Ritron Model(s):	LM-700DMR and RIB-700DMR
Current Firmware Revision:	47.23
Revision Update:	Jul 10, 2025

LM-700DMR and RIB-700DMR Firmware Revision and Update History

R614 vs. V22/V21

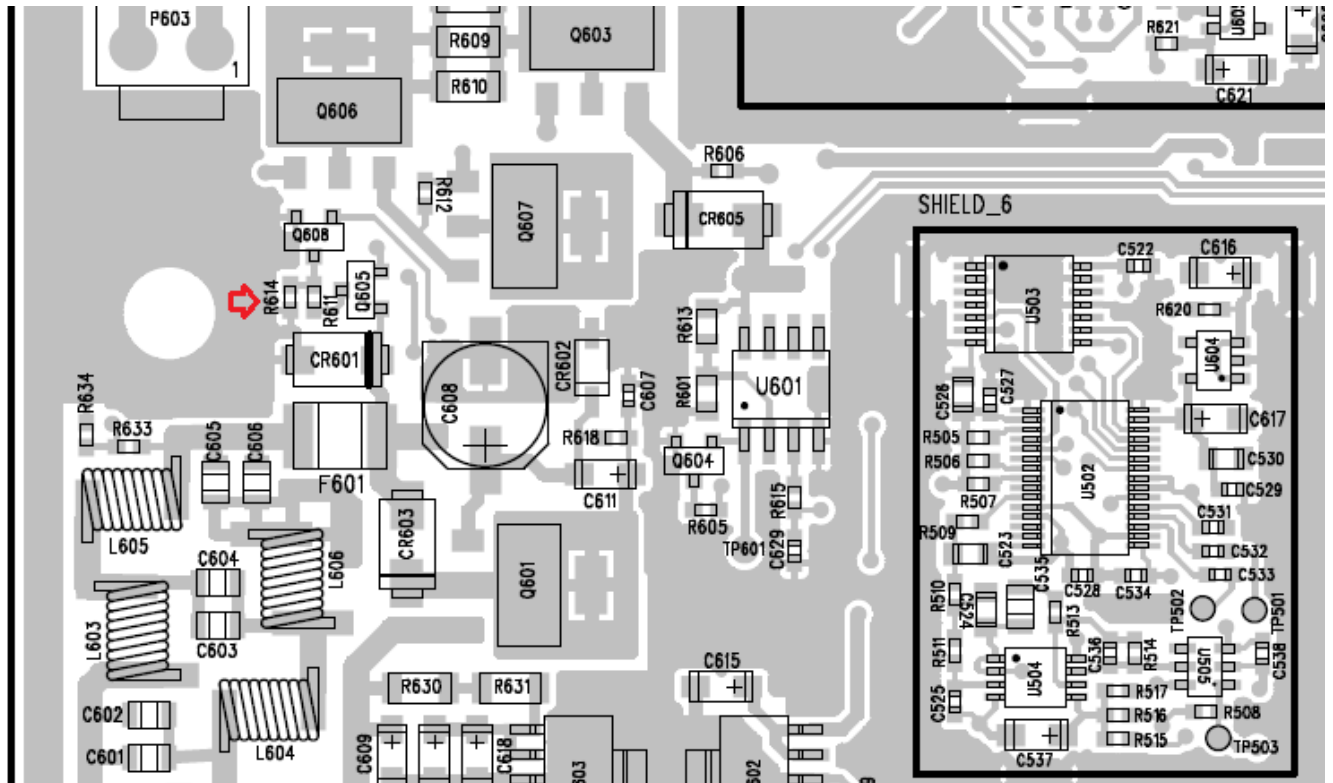
- 1) Added a feature that the unit can auto shutdown when 12V external power is lost and the battery is below 9.5V for at least 5 seconds. Before auto shutdown, the unit will beep 3 times. It is to prevent internal backup battery from over draining. To enable this feature, R614 (0 ohm) has to be removed. R614 was populated on the early units. With V22, if R614 is not removed, the unit will still work like V21, the battery dead auto shutdown just does not work. For the old version firmware, V21 and earlier, if R614 is depopulated, the battery backup function will stop working. i.e. depopulated R614 needs V22 or newer f/w to make the battery backup function work.

R614	Depopulated (new built)	Populated (old built)
F/W V22 and newer	Dead battery auto shutdown (lower than 9.5V) enabled	Dead battery auto shutdown (lower than 9.5V) is disabled, Same as V21 or older
F/W V21 and older	Battery backup function will stop working	Dead battery auto shutdown (lower than 9.5V) is disabled

Updated: Added above R614 part locator on Jul 8, 2025.
